Young High School Library and Community Facility Modification 3

State Significant Development Modification Assessment (SSD 9671 MOD 3)

December 2021

Subtitle: Landscaping Amendments

Figure 5 | Proposed Changes to Carrington Park (Source: Mod 2 Plans 2021)

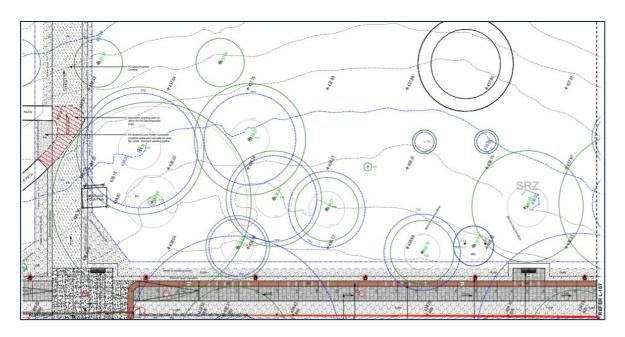
Retention of existing trees

The applicant has advised that Hilltops Council requested the retention of additional trees within the council owned Carrington Park.

The trees approved for removal under the SSDA consent now proposed for retention include:

- Tree 12 Grevillea robusta Silky Oak;
- Tree 13 Ulmus glabra lutescens Golden Elm;
- Tree 14 Ulmus glabra lutescens Golden Elm;
- Tree 21 Ulmus glabra lutescens Golden Elm;
- Tree 23 Picea pungens Blue Spruce;
- Tree 26 Cedrus deodara Himalayan cedar;
- Tree 30 Eucalyptus cinerea Argyle Apple; and

• Tree 31 - Cedrus deodara Himalayan cedar.

Amendments to proposed paving and paths

A range of amendments are proposed to the approved paving and paths. Changes include:

- the retention of the path to the TAFE entry;
- the P3 path located in front of Carrington Park width is to be reduced to 2.5m, and
- removal of the P6 Decomposed Granite path located in Carrington Park.

These amendments to the proposed paving and paths have been requested by Hilltops Council, as these additional works are no longer required and will minimise the impact of the development on the park.

In addition, the proposed path (P6) is to be removed surrounding the Reconciliation Tree, as the Project Arborist has advised the originally approved proposed works would likely cause damage to the Reconciliation Tree. Council has also advised no works are to be undertaken near or around the Reconciliation Tree, to prevent damage to the tree roots and minimise the impact to the park.

Removal of seating and lighting

The proposed seating along the path adjoining Carrington Park is to be removed, as the Park already provides adequate seating. A single seat is to be retained in the middle section of the path and has been refined to satisfy *Disability Discrimination Act 1995* (DDA) compliance for seating/resting areas every 60m as required.

The modification also proposes relocation of lighting to the northern side of the path in order to avoid both Tree Protection Zones and the requirement for trenching electrical conduit near the existing heritage fence.

Removal of gravel

The gravel edging located north of the Carrington walk is proposed to be removed as it currently is partially located within Carrington Park. Council has requested the edging be removed to further minimise the development's impact on the park and this additional work is no longer required.

The Department has reviewed the SOHI and is satisfied that the impacts of the proposed modifications have been adequately addressed. The Department is satisfied that the proposed retention of the trees will reduce ground disturbance and thus avoid potential impacts to archaeological deposits associated with the Lambing Flat Riots. The proposed tree removal within the quadrangle area is also unlikely to disturb archaeological deposits as the tree root systems are to be left in situ. Further, the reduction of the concrete seating walls will reduce the extent of subsurface impacts by removing the requirement for footings and will be visually sympathetic to the aesthetics of the Court House.

The Department has reviewed the modification report and landscape plans detailing the justification for the proposed design amendments, the Department is satisfied that the proposed Landscape design changes associated with Carrington Park provide a better design outcome for the public domain, noting the local Council's endorsement of the proposed changes. The proposed design changes would not change the bulk and scale of the development, whilst allowing additional mature and healthy trees to be retained within the park.

Figure 6 | Proposed Changes to Carrington Park (Source: Mod 2 Plans 2021)

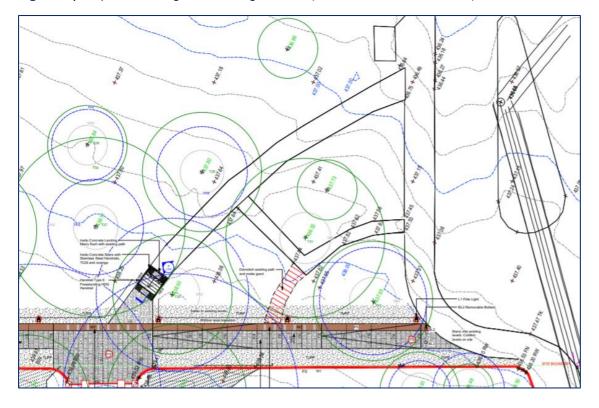
In addition to the requested changes by Council, the path from the Waterwise garden is to be demolished and the stairs connecting to the existing path near the Waterwise Garden is to be amended, in order to achieve compliant grading of paths as required as per Australian Standard 1428.1.

The removal of the stairs connecting to the Court House and its replacement with walls and planters is proposed to address the potential for structural instability of the Court House Building. It is not envisioned that this will result in a detrimental impact to the heritage significance of the subject site. Finally, the removal of the decomposed granite path (P6) and reduction of the P3 path width is

unlikely to result in any inadvertent impacts to archaeological deposits, this is also captured within existing conditions of consent, specifically B22 which requires historical archaeological investigations to be undertaken by a suitably qualified and experienced historical archaeologist prior to construction.

Figure 7 | Proposed Changes to Young Library (Source: Mod 2 Plans 2021)

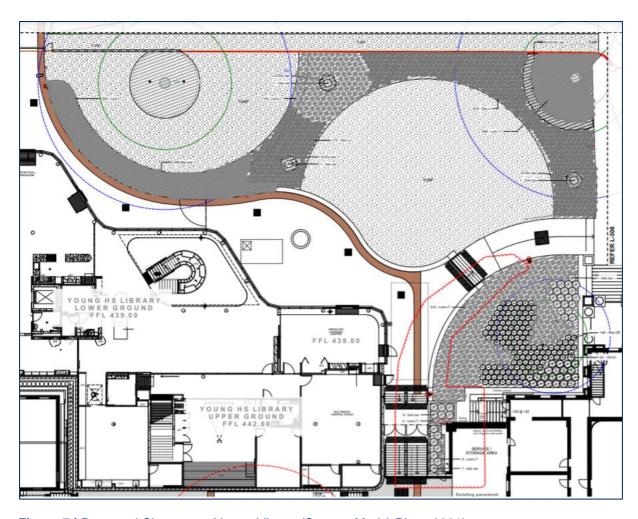
2.1.3 Amendments to proposed paving, paths and stairs surrounding the library

Multiple paths finished material are proposed to be modified. P1 paving is now Educational Facilities Standards and Guidelines (EFSG) insitu concrete and was updated to the Educational Facilities Standards and Guidelines (EFSG) for school pavements. Similarly, the P3 paving has been changed to insitu concrete with a sawcut pattern from a brick paving.

The P5 Wiradjuri Line has been removed on the stairs, the applicant advised this is for both maintenance and overall visual impacts.

There are a number of miscellaneous and minor modifications as a result of the amended landscape design surrounding the library and broader area of Young High School. The minor landscaping design changes including reducing the proposed new steps adjacent to the courthouse west wing wall, minor retaining wall changes, and the installation of new fence, egress gate and ramp.

Figure 8 | Proposed Changes to Young Highschool Area (Source: Mod 2 Plans 2021)

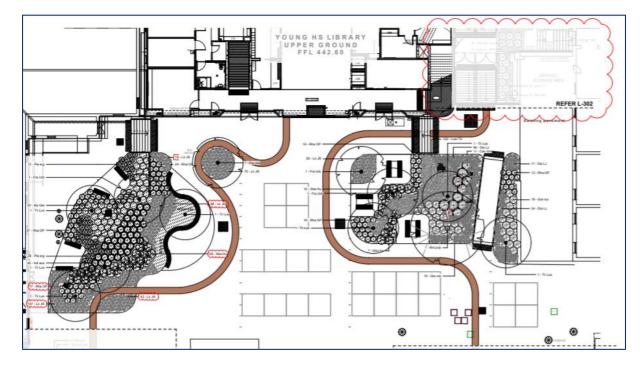
2.1.2 Updates to landscape design of internal school quadrangle

Detailed assessment completed by the consulting arborist concluded that the works as approved will detrimentally impact two large existing trees that were originally approved to be retained.

The consulting arborist identified that two existing trees (T66 – Lemon Scented gum and T65 – Chinese elm) located in the internal school quadrangle are required to be removed due to the approved works imposing detrimental requirements on the trees such as significant pruning.

In lieu of the removal of trees, additional garden beds are proposed, and 10 additional semi mature trees will be planted within the internal courtyard to compensate for the loss of tree canopy and shading.

Young High School has requested the new garden beds be raised, to delineate the gardens from the play area/walkable area to prevent students from walking through the gardens and to prevent mulch in the garden beds from being spread across the playground.

Redesign of playground

The redesign of the playground includes the removal of the proposed wooden deck and increase in the concrete area. An additional asphalt area, bench seating and tables are to be introduced for use by students.

As a result of the softfall and concrete redesigns, the stormwater and grated trench drains are proposed to be amended accordingly. All bench seating and tables will be Educational Facilities Standards and Guidelines (EFSG) compliant.

The proposed landscaping changes within Young Highschool are considered to be sympathetic of the future use as a school quadrangle and are designed accordingly. The proposed removal of trees is supported on the basis that construction impacts are likely to detrimentally impact the identified (2) trees for removal and suitable replacement planting is proposed.
